HYUNDAI Technical Service Bulletin

GROUP RECALL	NUMBER 24-01-078H
DATE SEPTEMBER 2024	MODEL(S) TUCSON (NX4M)

SUBJECT: SRS WARNING LABEL APPLICATION FOR GLOVE BOX
(RECALL 268)

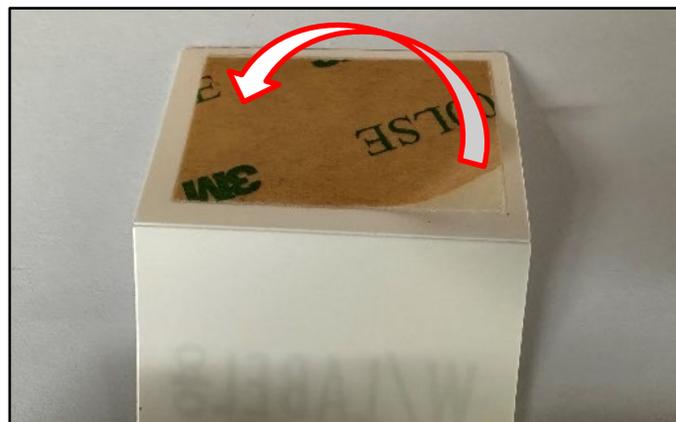
1. Locate the SRS warning label (A).

2. Remove the tape cover.

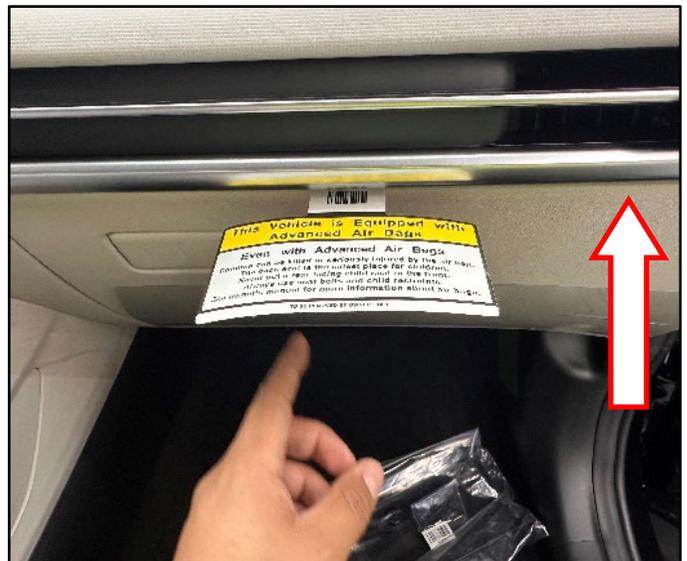
3. Apply the label to the center edge of the glove box.

Press firmly to ensure the label properly adheres.
